## Addendum #2

RE: REQUEST FOR TENDER #2024-137-P01947  
Hess Street Elementary School – Renovation Project

April 30, 2024

**PROJECT TITLE**  
PARTIAL GROUND FLOOR PLANS - GENERAL - DEMOLITION & NEW

**3 PARTIAL GROUND FLOOR PLAN - DEMOLITION**  
SCALE: 1/4"=1'-0"

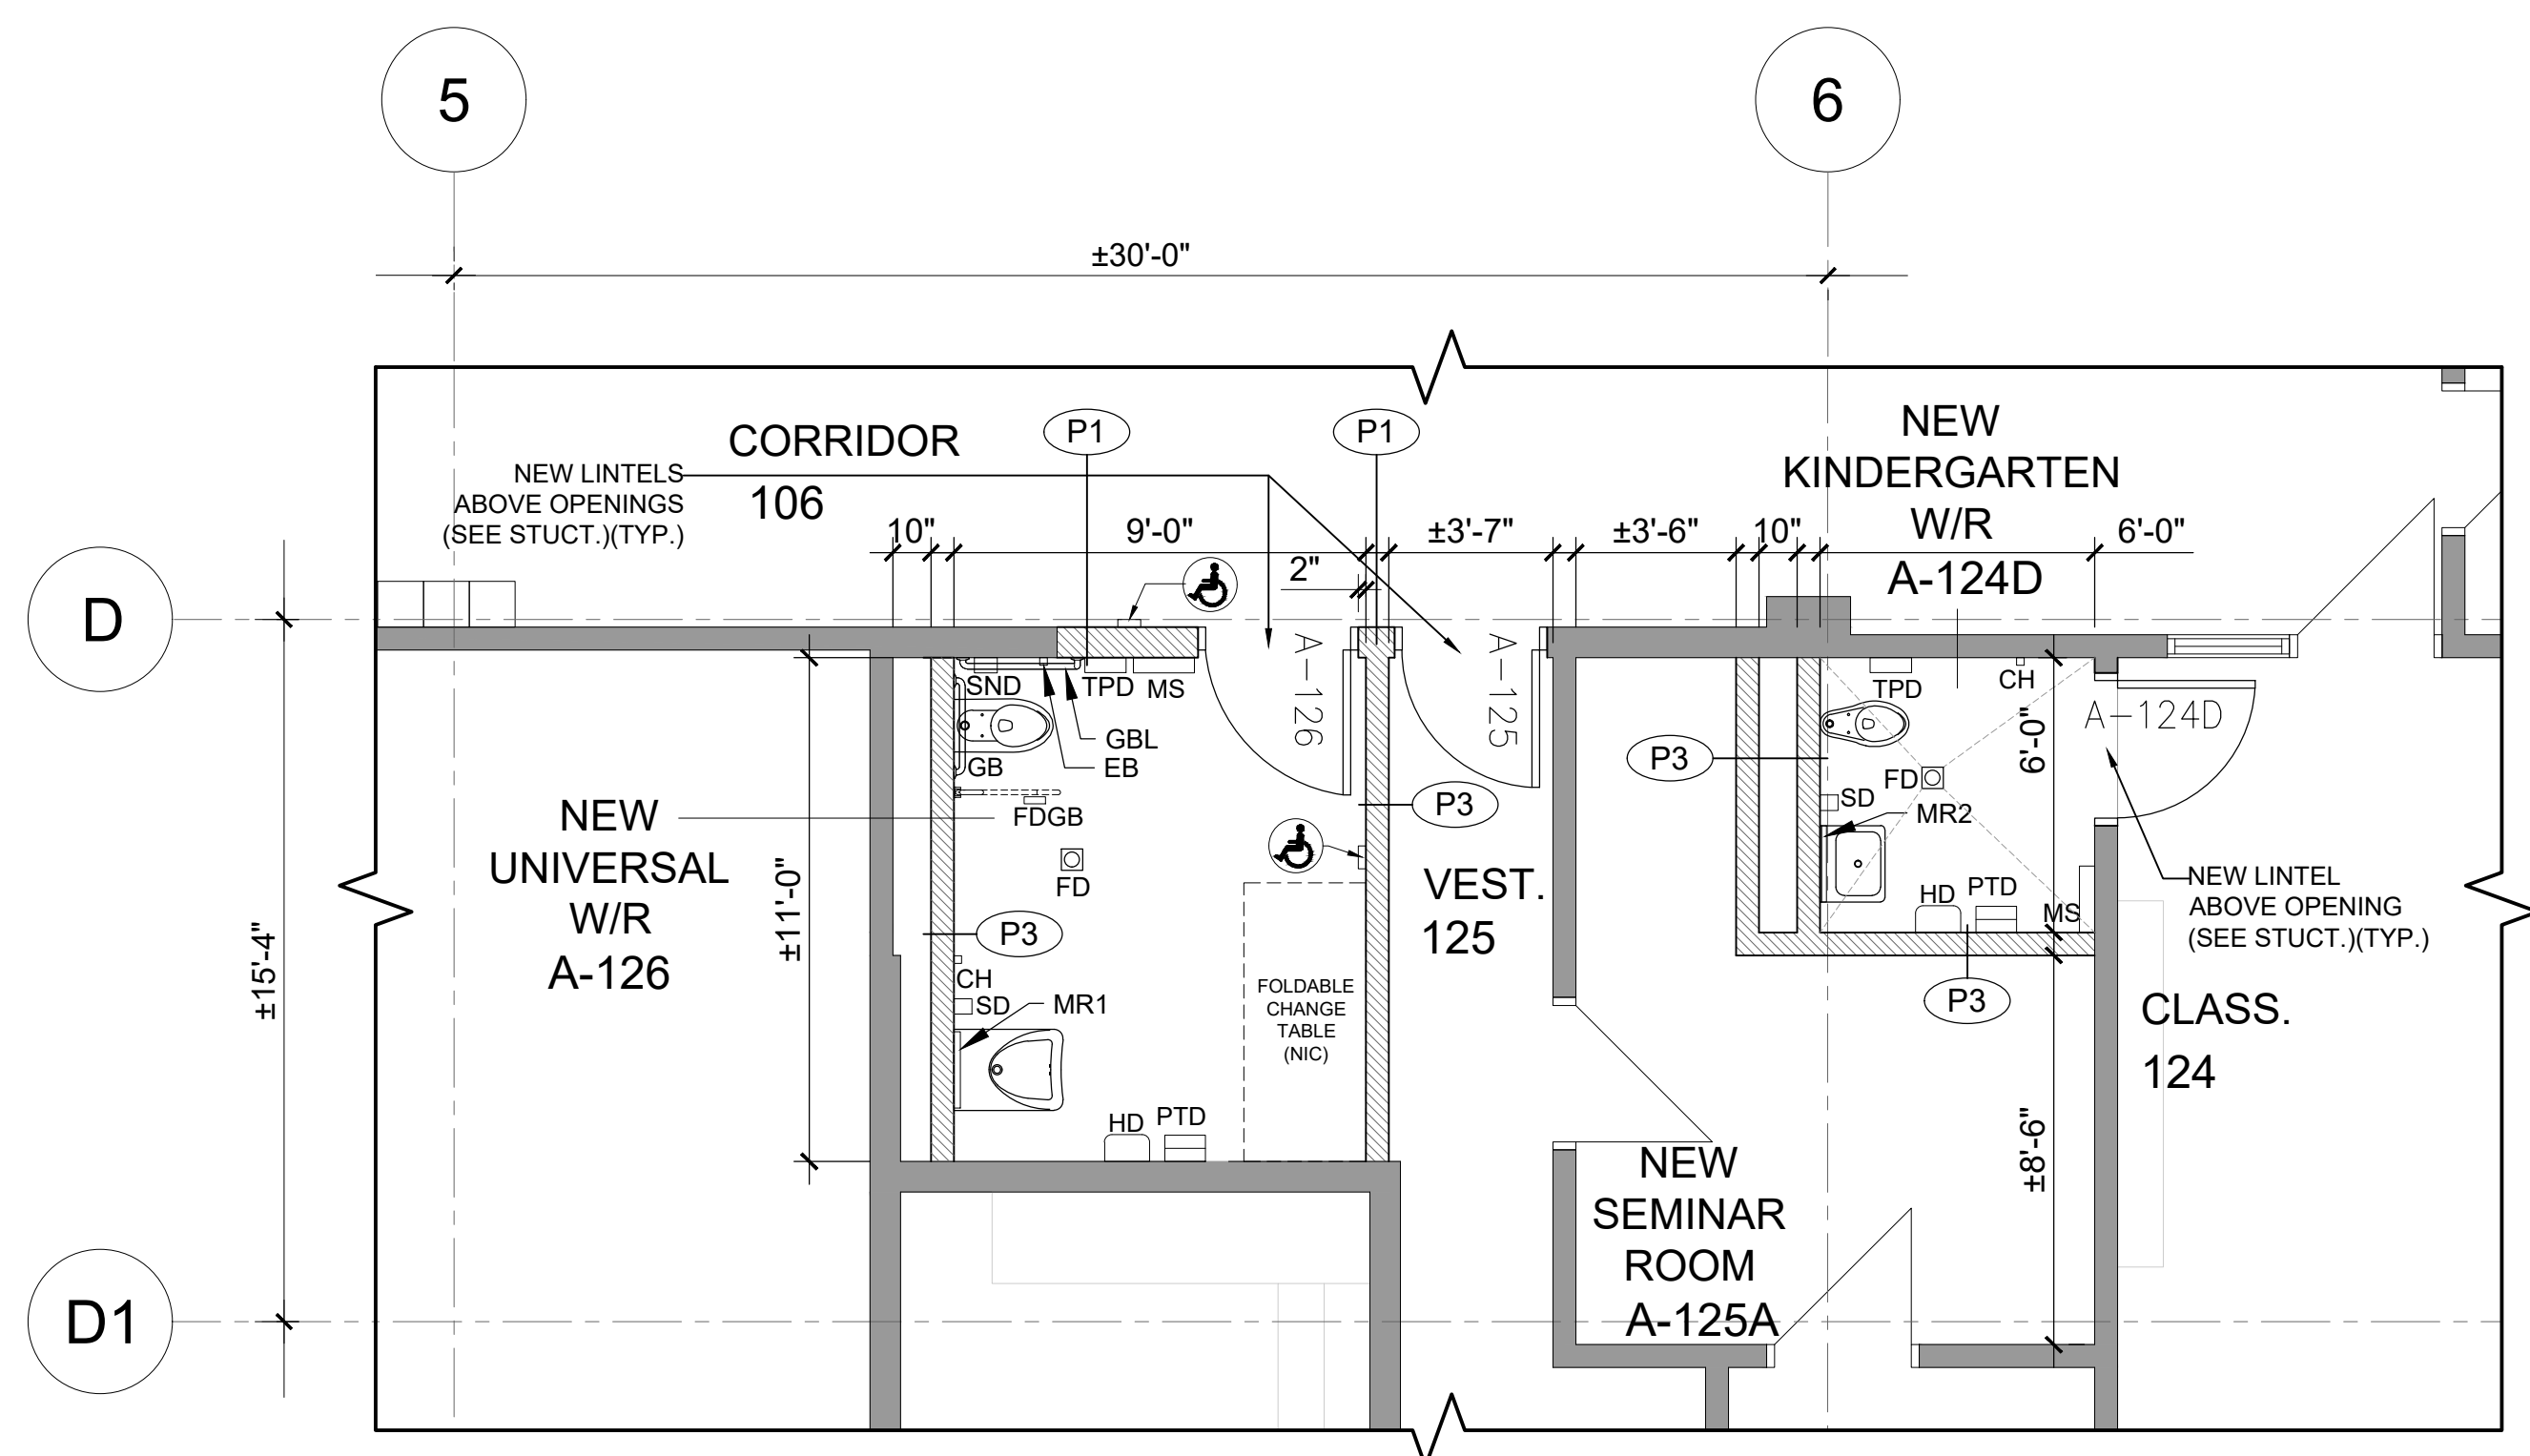
- 1) **Clarification:** In Gymnasium #105 all existing conduits to also be painted like the walls.
- 2) **Clarification:** Since the work is being performed during summer while the school is closed, new 1 hour rated construction hoarding partition (as shown on drawings A101 and A102) may be replaced with new Poly Tarps protection sheets.
- 3) **Clarification:** Refer to clarifications regarding Partition Types P1 and P2 in the attached Architectural drawings A101 and A102, dated April 30, 2024.
- 4) **Question:** On behalf of Gerflor Canada we request Rec6.2mm replace Multi-Use 6.2 to Section 096566 Resilient Athletic Surfacing Item #2.1.1 as the true equivalent to MultiFlex. Thank you.

DATE: 11 APRIL, 1973  
SCALE:  
DRAWN BY: CHECKED: S.P.  
PROJECT: TISS  
SET NO. DRAWING NO.  
**S1**

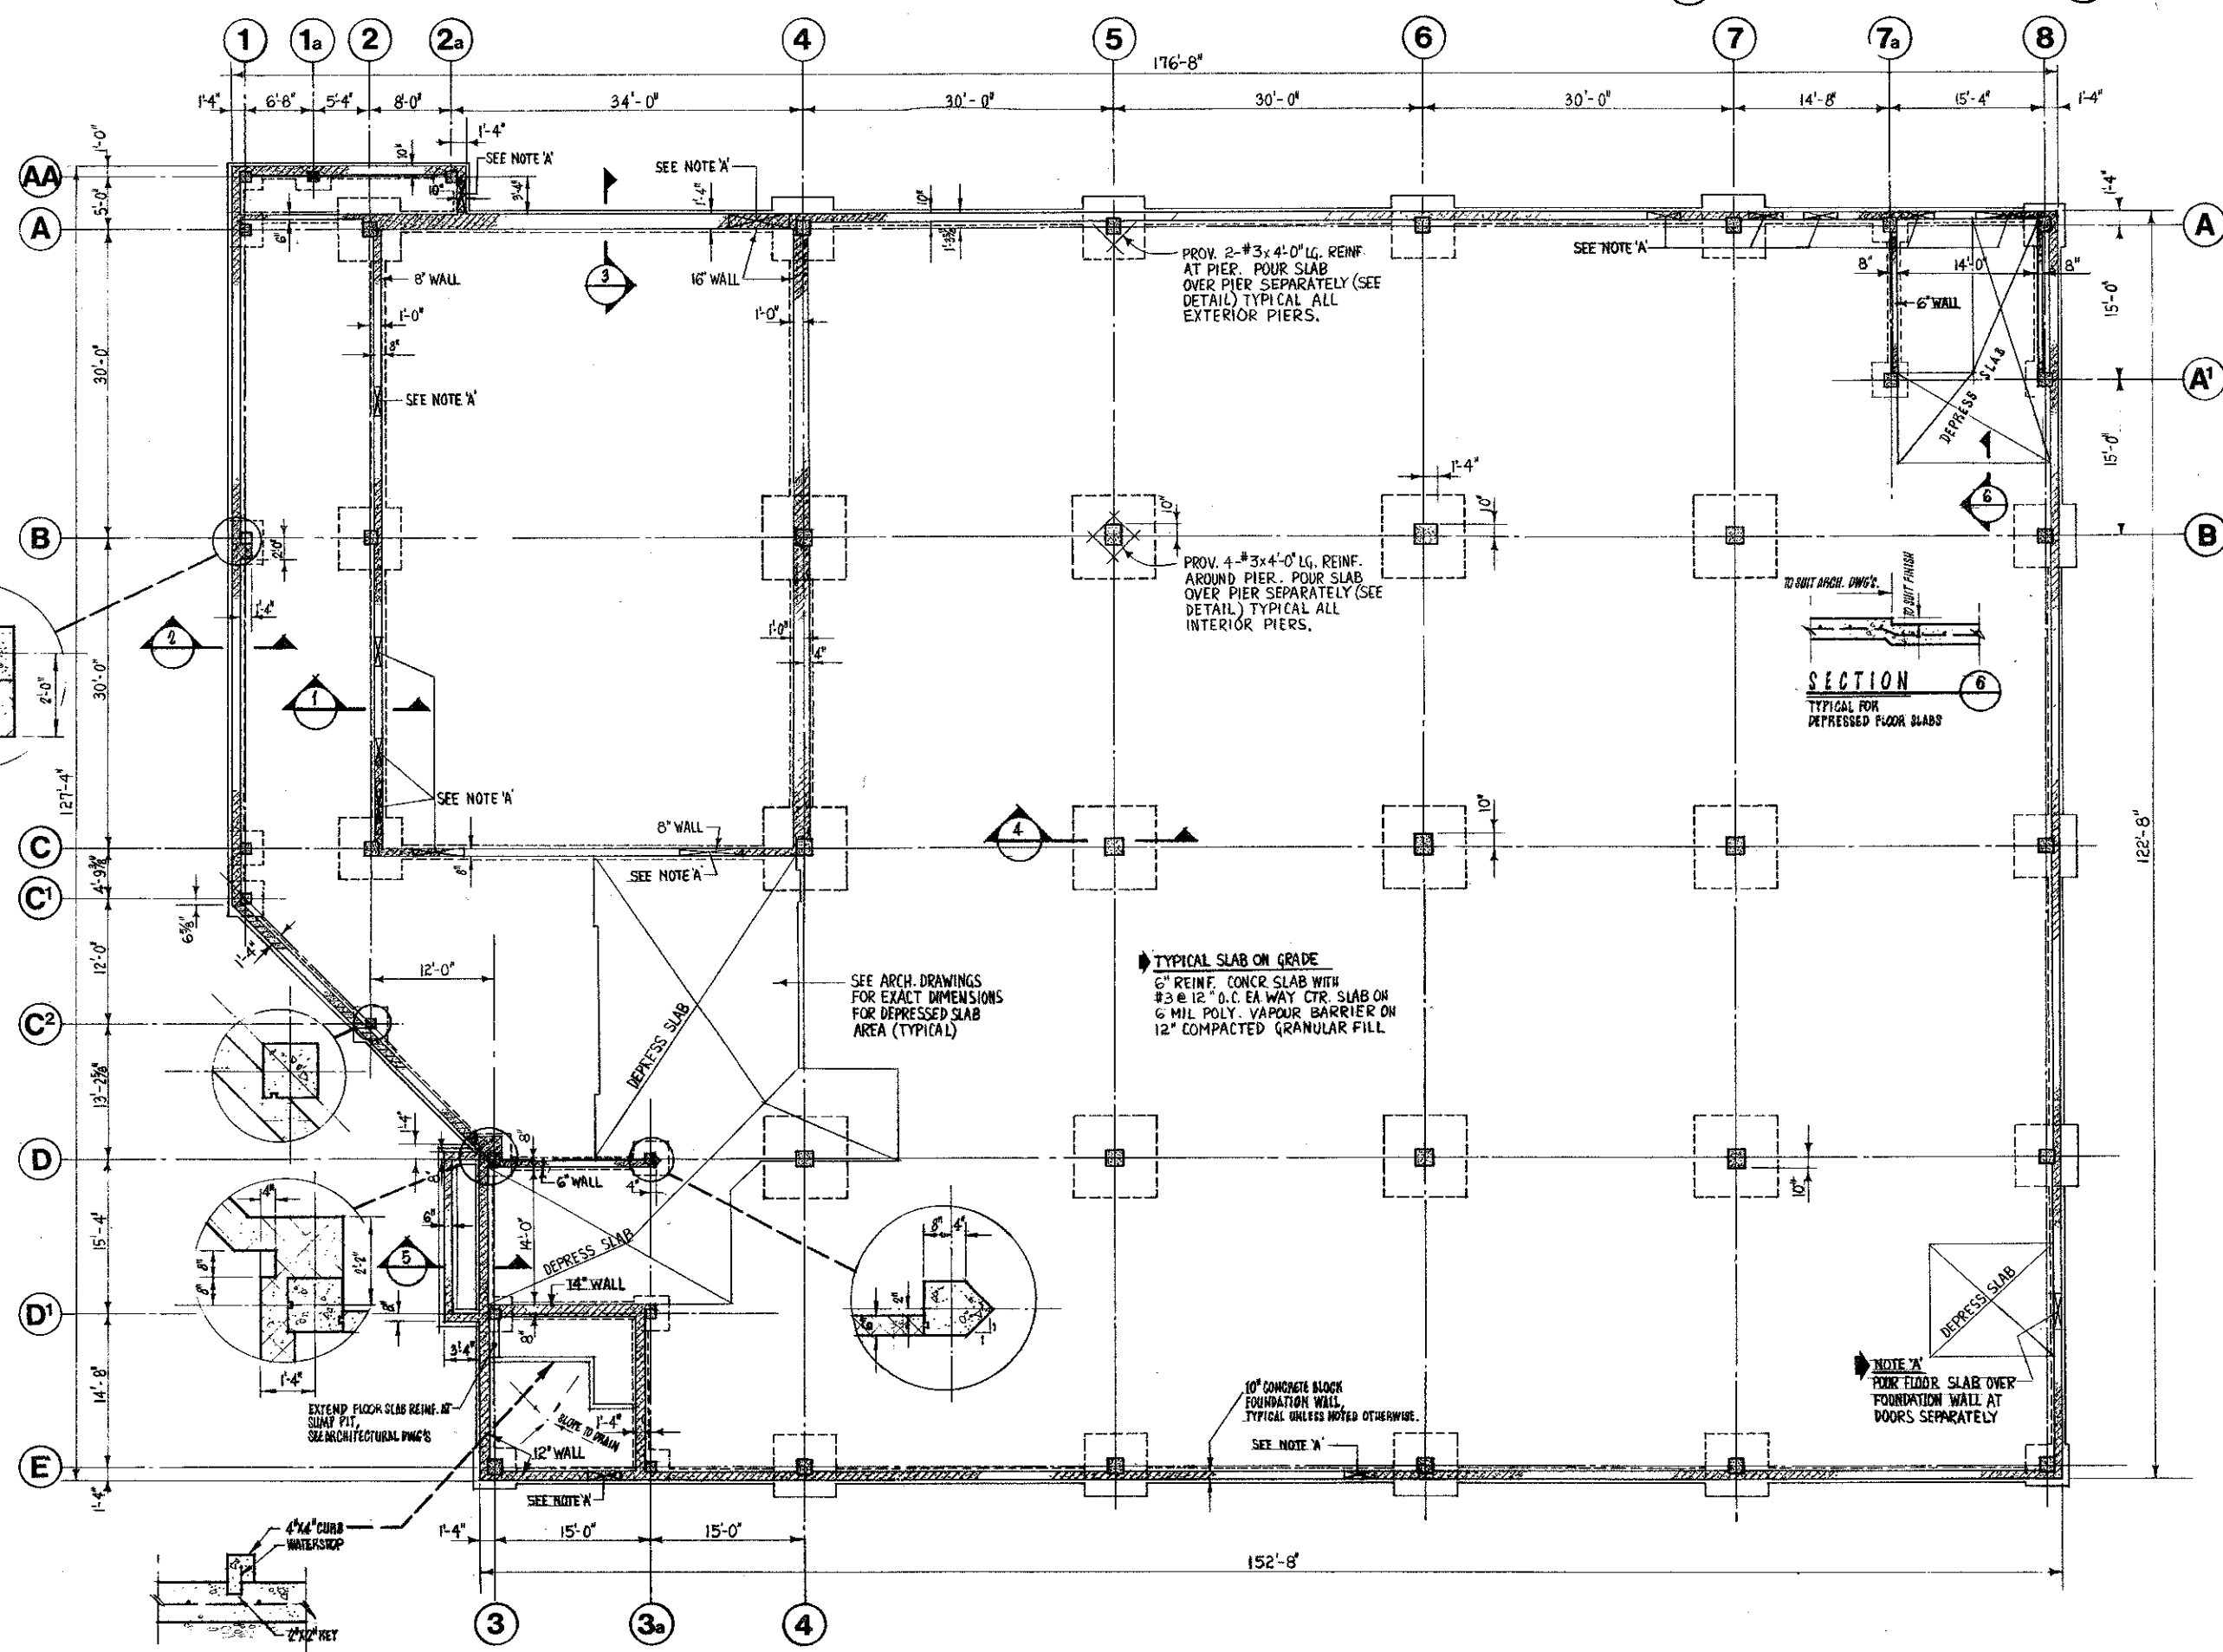
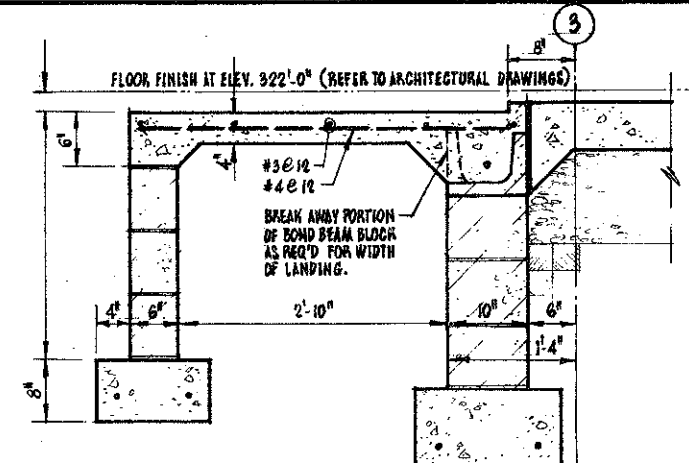
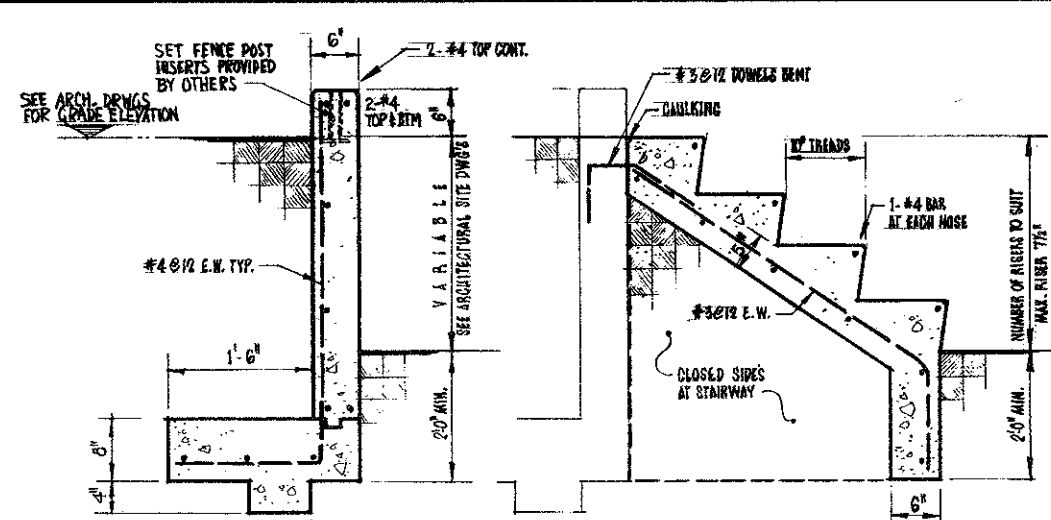
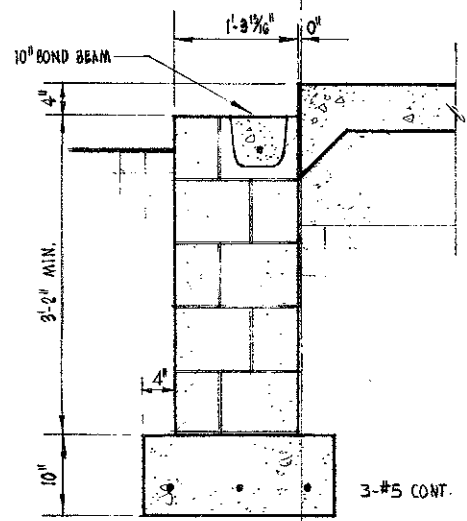
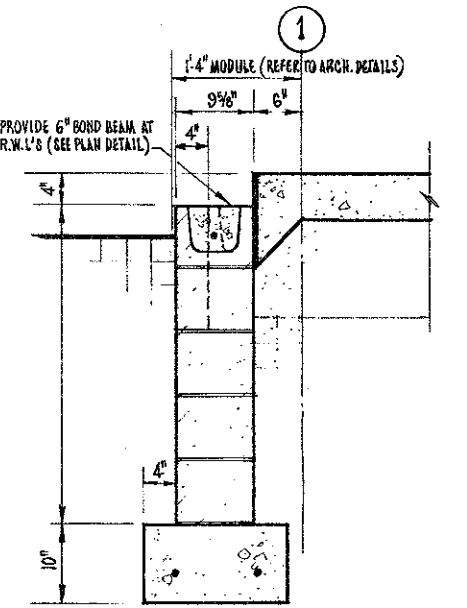
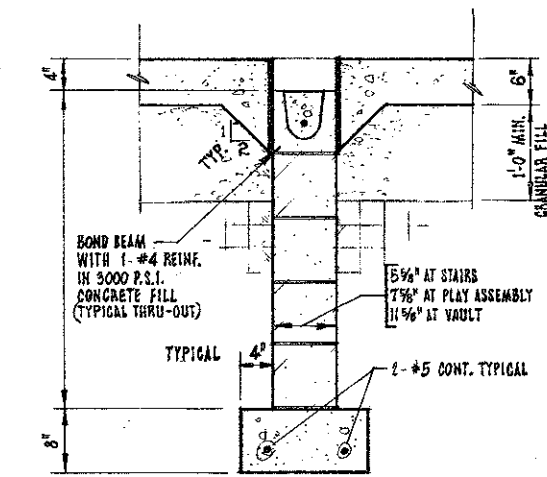
- 7) **Question:** Please provide the thickness of the slab in rooms 125, 115, 125, and corridor 106? Required for trenching purposes.

**Answer:** Refer to attached existing Structural drawing S1 Foundation Plan and Details dated April 11, 1973.
